Georgia Department of Natural Resources

December 1, 2014

Subject: Attention Docket ID No. EPA-HQ-OAR-2013-0602
Georgia EPD November 2014 Comments on the Proposed Carbon Pollution Emission
Guidelines for Existing Stationary Sources: Electric Utility Generating Units

Figure 1. – CO₂ Reductions Required in Georgia Emissions Performance Targets Over Time, per EPA Goal Computation TSD

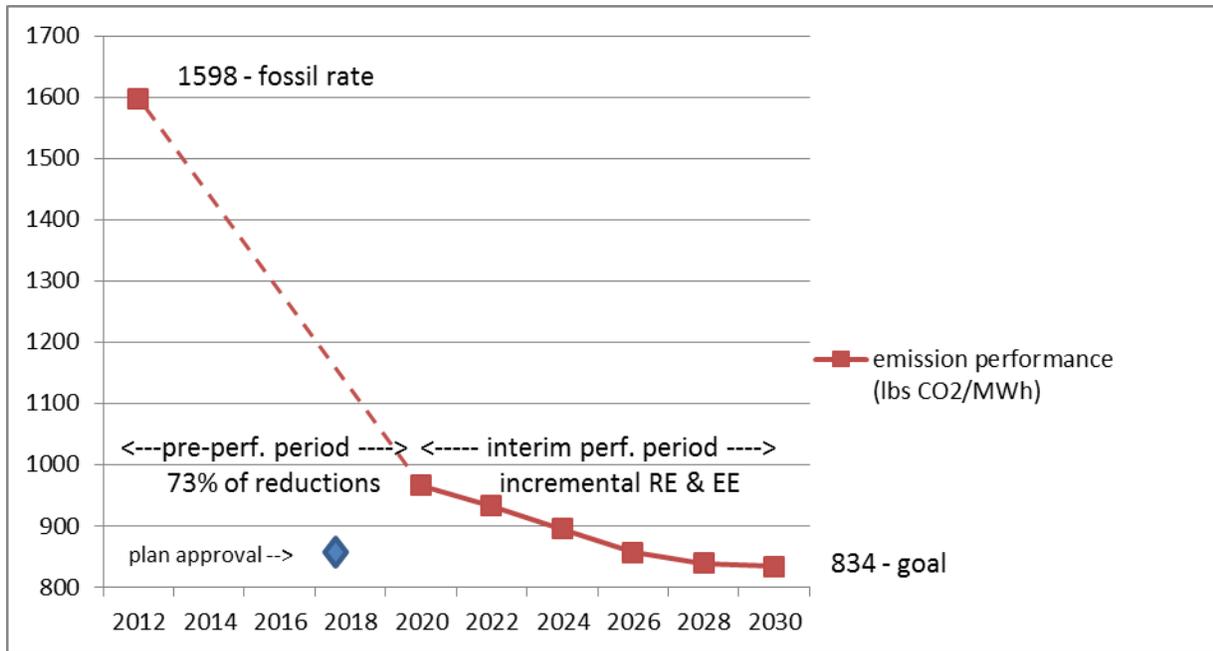
According to the emissions rate schedule published in the appendix to the Goal Computation TSD, Georgia's target for the 2020 calendar year would be 966 lbs. CO₂/MWh and the ten-year average interim goal is 891 lbs. CO₂/MWh (from the Goal Computation TSD). Although EPA states that there is flexibility to fall behind at the start of the period and make it up later, this would be very difficult to do in light of the cumulative averaging nature of the goal. The further a state is into the interim period, the harder it is to improve the average. EPA has targeted a reduction in emissions performance from 1598 lbs. CO₂/MWh in 2012 (fossil sources) to 966 lbs. CO₂/MWh in 2020 (see Figure 1 below) through implementation of all BSER except incremental RE and EE. This reduction amounts to 73 % of the overall reduction in Georgia's emissions rate reduction from 2012 to 2030. EPD sees no reason to require the significantly steep reductions in the first few years of a 15 year plan.

EPA’s proposal therefore requires Georgia, and many other states, to make significant CO₂ emission reductions prior to 2020. Georgia must implement the following changes to its energy sector prior to 2020 in order to have a chance of meeting EPA’s interim goal:

likely that there will be delays in the approval process. Georgia EPD believes that there is simply not enough time to implement the actions listed above between plan approval and January 1, 2020. As stated above, EPD believes the interim goal should be replaced with a state developed glide path. However if an interim goal is retained, EPA should move the start of the interim period to five years after EPA's approval of the state plan, and retain the starting emissions performance target and interim period average as set in the final rule. This should allow time to implement the plan and achieve interim emission rates, while retaining an advance progress-tracking period of adequate length.

If the interim goal is retained, delay the start of the interim compliance period to five years after EPA's approval of the state plan.

Figure 3 – EIA Natural Gas Price Forecasts

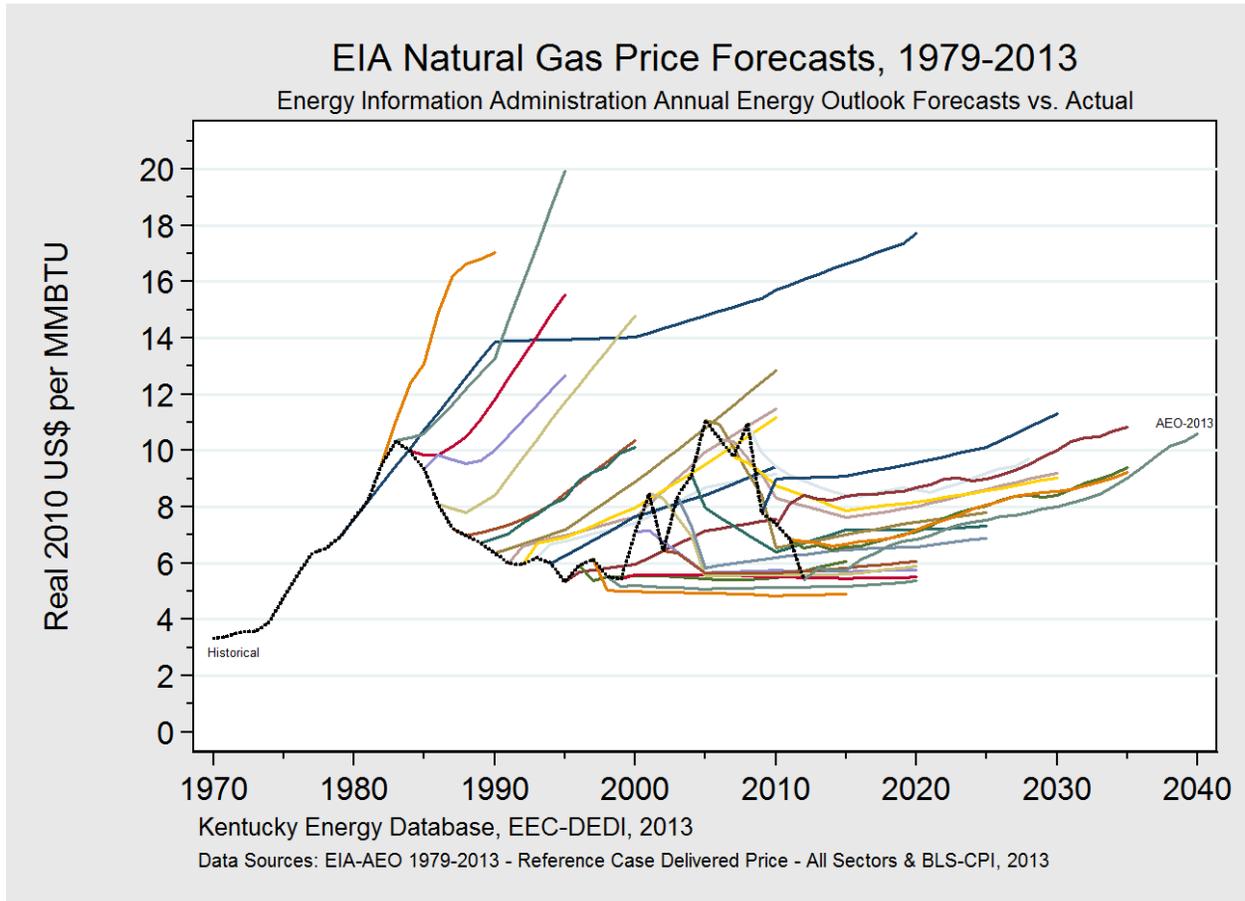
The Clean Power Plan relies heavily on the assumption that natural gas will continue to be inexpensive and plentiful. Thirty percent (30%) of Georgia’s CO₂ BSER reduction target is Building Block 2 natural gas re-dispatch. EPD agrees that most current projections suggest that natural gas prices will remain low for the short-term future. However, projections are just that, *projections*. Historically, projections of future

energy prices (even within relatively short time periods) have been notoriously inaccurate such as the recent steep declines in natural gas prices as shown in Figure 3 below.¹⁹

EPD requests that EPA include in its Clean Power Plan a “safety-valve” in the event that natural gas prices rise rapidly due to some type of market disruption. For example, a large natural disaster or a significant national security issue may cause a temporary price spike in natural gas prices, or a sharp curtailment in the availability of natural gas at any price. The “safety-valve” mechanism would allow a temporary relaxation of the natural gas dispatch targets in the affected State in order to ensure grid reliability.
